## Accessibility Audit Report

# Ringsend to City Centre Core Bus Corridor Scheme

## Accessibility Audit Report

Project Title			
BUSCONNECTS INFRASTRUCTURE DUBLIN			
Drawing Title			
ROUTE 16: RINGSEND TO CITY CENTRE ACCESSIBILITY AUDIT			
Drawing File Name	Sheet Number	Status	Rev
BCIDD-ROT-PMG_PS-0016_XX_00-AU-CR-0009	09 of 10	SO	K01

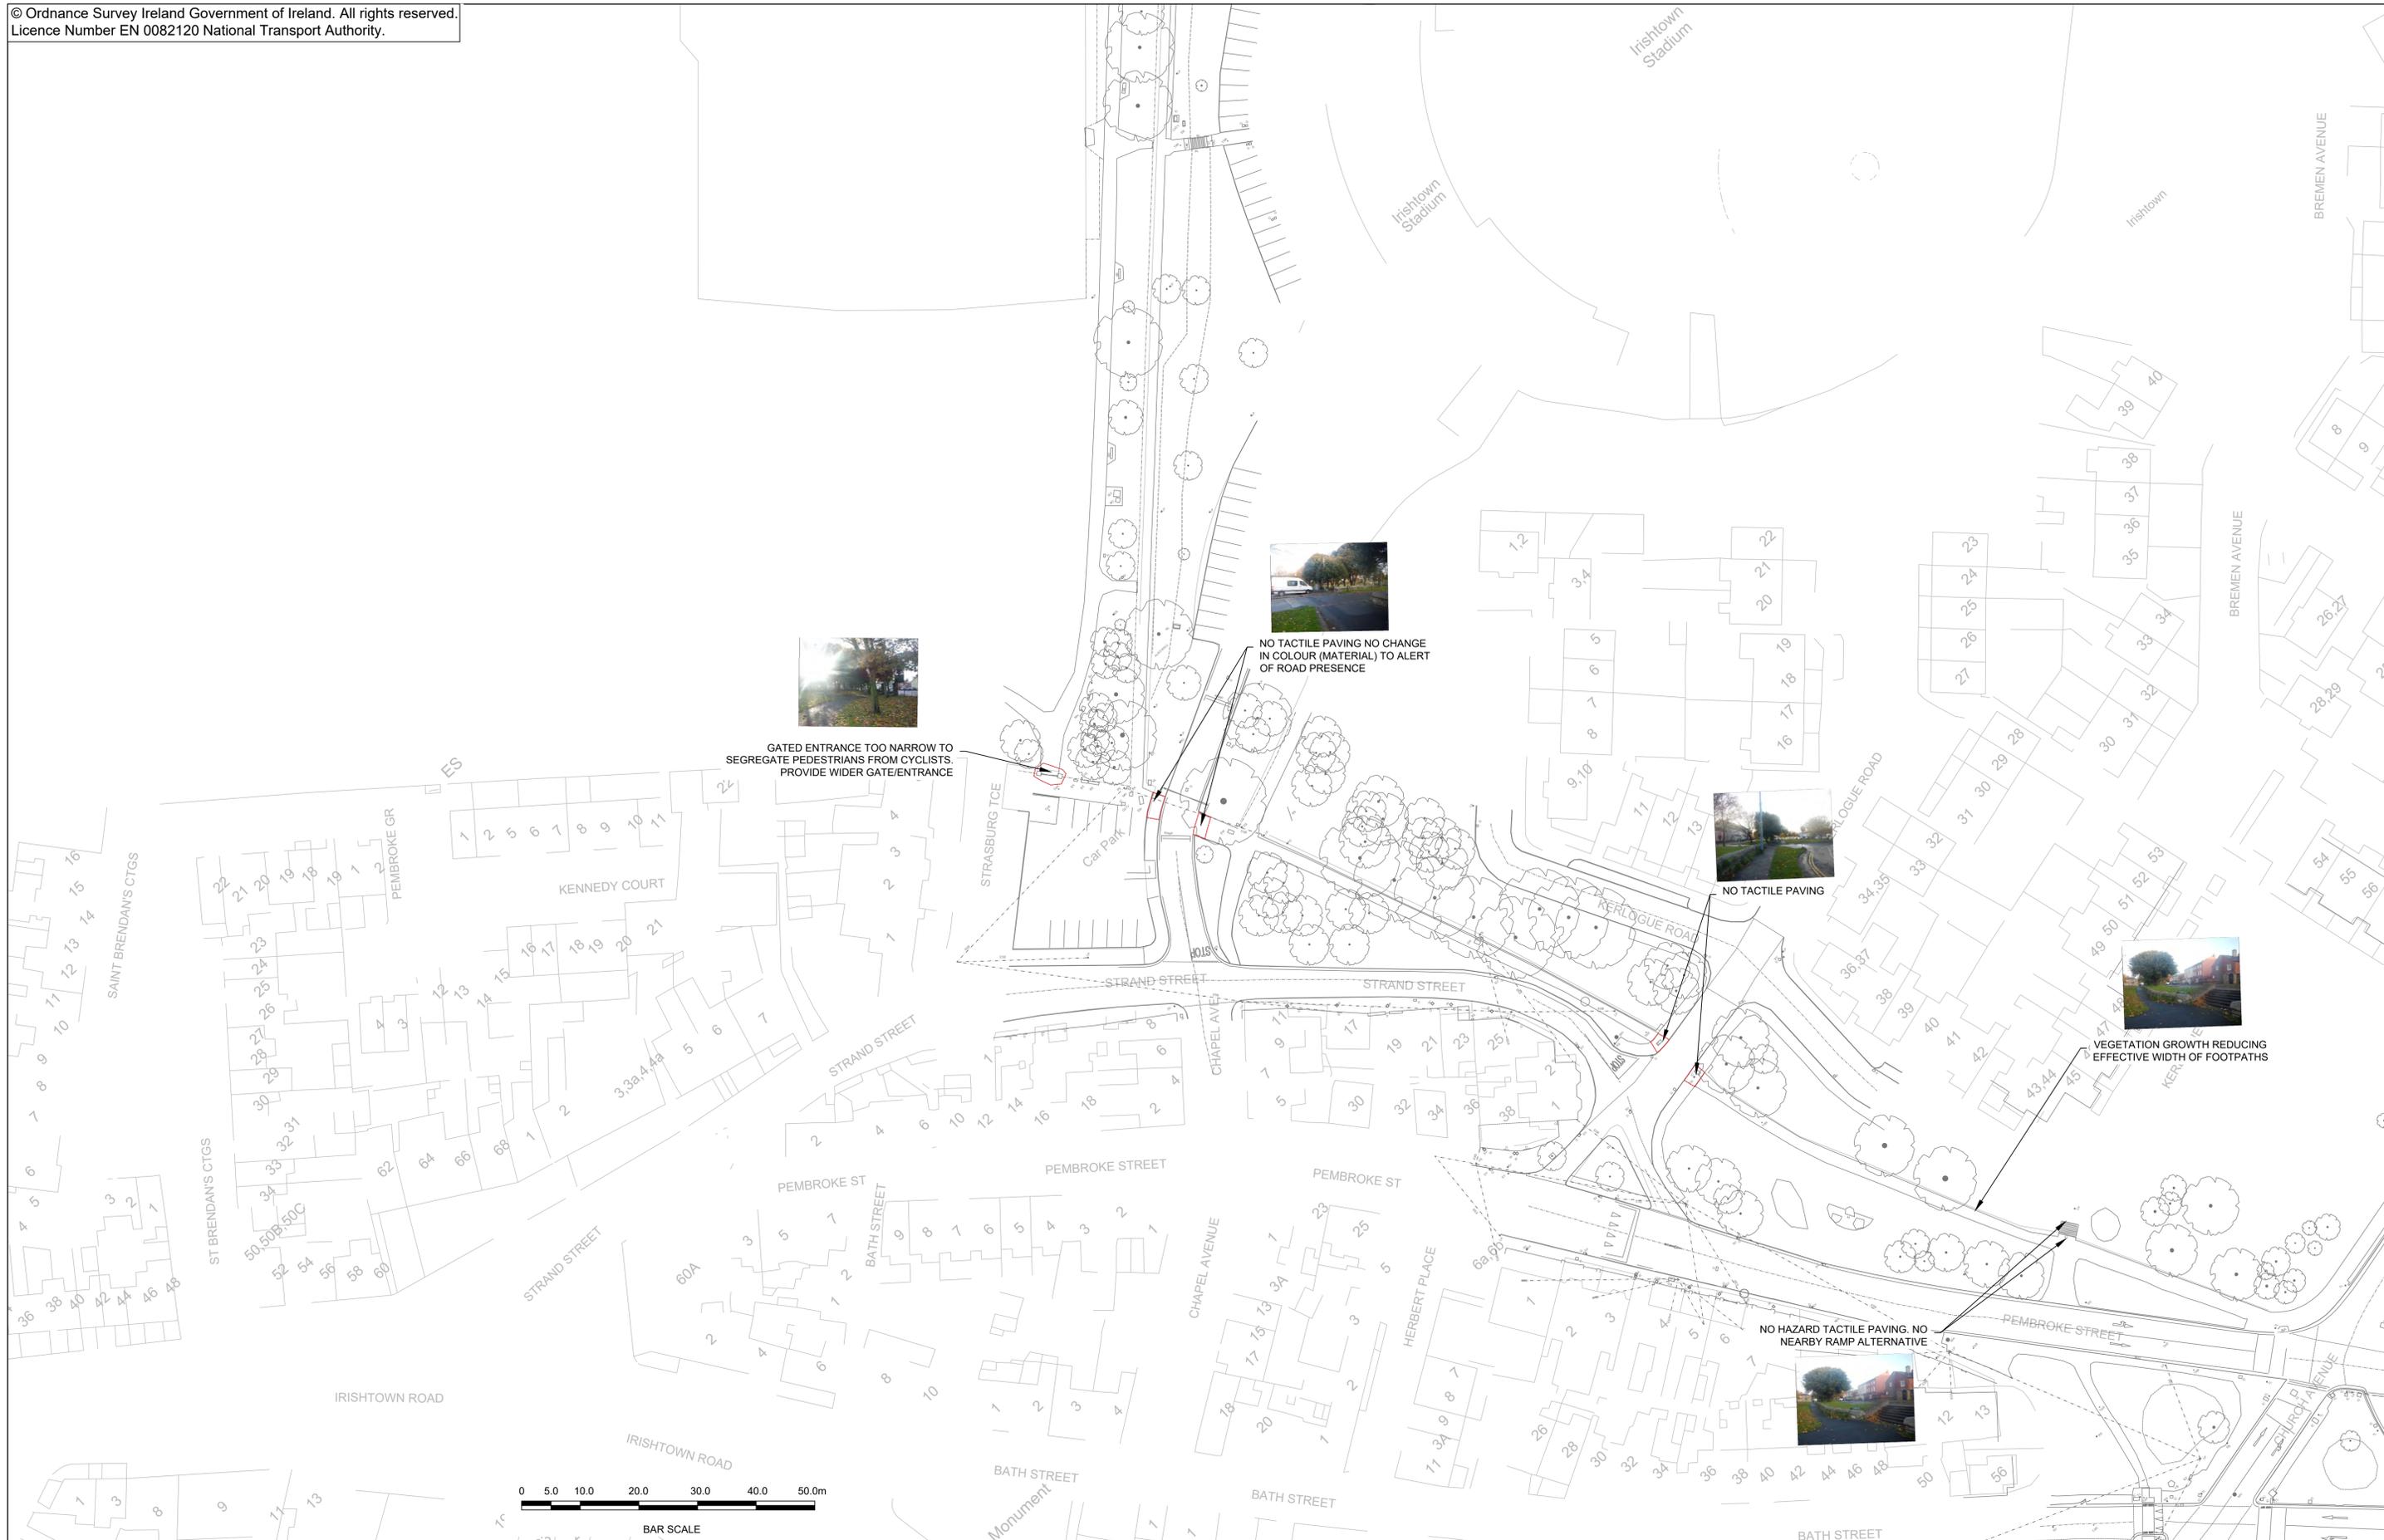
BCIDD-ROT-PMG_PS-0016_XX_00-AU-CR-0009	No hazard tactile paving at crossing. Buff tactile paving shall be used at uncontrolled crossings. The dropped kerbs at the uncontrolled crossings are located on the curve of the road and not in the direct line of travel	Yes	Yes	All tactile paving requirements will be reviewed as part of the Detailed Design process. Pavement and Kerbs types will be reviewed during Detailed Design
BCIDD-ROT-PMG_PS-0016_XX_00-AU-CR-0009	Access gate too narrow for pedestrians and cyclists to use. Provide a wider gate/ entrance and minimise or design out any shared interactions between modes	Yes	Yes	Wider gate provided
BCIDD-ROT-PMG_PS-0016_XX_00-AU-CR-0010	Gated entrance too narrow to segregate pedestrians from cyclists. Provide wider gate/ entrance	Yes	No	The existing entrance is wide enough to allow a shared entrance.
BCIDD-ROT-PMG_PS-0016_XX_00-AU-CR-0010	No hazard tactile paving at crossing. Buff tactile paving shall be used at uncontrolled crossings.	Yes	Yes	Crossing for cyclist and pedestrian updated with ramp. Pavement types will be reviewed during Detailed Design
